**Government of India**  
**Ministry of Railways**  
**Research, Designs & Standards Organisation**  
**Manak Nagar, Lucknow - 226 011**

No. EL/3.2.10/8

**MODIFICATION SHEET NO. RDSO/WAM4/110**  
**MODIFICATION TO CUTLER HAMMER RELAY (Q48) FOR**  
**MINIMISING MICRO SWITCH FAILURES**

REVISED CABLE CONNECTION FOR Q48

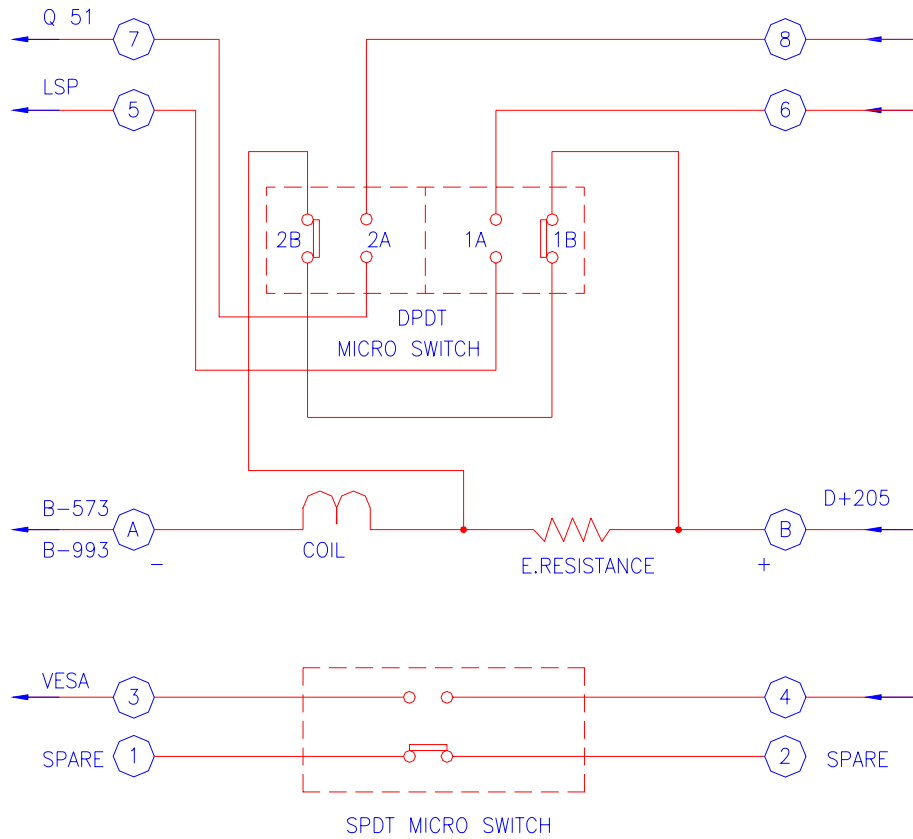
One of the causes of failures of Q48 Double pole micro switches is likely to be interchange of wires No.B-573/B-993 and D4205 at the relay terminal board. It may be seen from the relay wiring diagram(see SK. EL.-3379)that by inter-changing these incoming/outgoing leads, the normally closed contacts will be at negative potential where as the adjacent normally open contacts will be at positive potential. The contact gaps being very small, there is a possibility of these two circuits getting short circuited inside the micro switch because of the close proximity of positive and negative potentials.

It is indicated on the switch that the wires connected to the micro switch should of the same polarity. the object of this modification is to ensure availability of the same positive polarity on the micro switch terminals and to utilise the spare contact in series with the existing self interlock of the relay.

**2.1.1** Connect the spare contacts in series with the existing self intrlock by using PVC cable with crimped sockets as shown is the sketch. This will minimise the arc severity while contorlling the economy resistance.

Ensure that all the incoming positive supply leads are connected on the right side terminals and out going leads on the left side terminals of the relay terminal board as indicated in the drawing No.SK EL.3379.

Remove the relay and rearrange the cable connections conforming to drawing SK. EL. 3379.

**2.3** Test the above terminations with a test lamp between earth and each terminals in the top row of the 11D and right side row of the relay terminal board (Read side). Lift QD for getting feed to the right outer terminal (i.e. self interlock) of the DPDT switch.

**2.4** Mark symbols '+' at terminal 'B' and '-' at terminal 'A' with white paint.
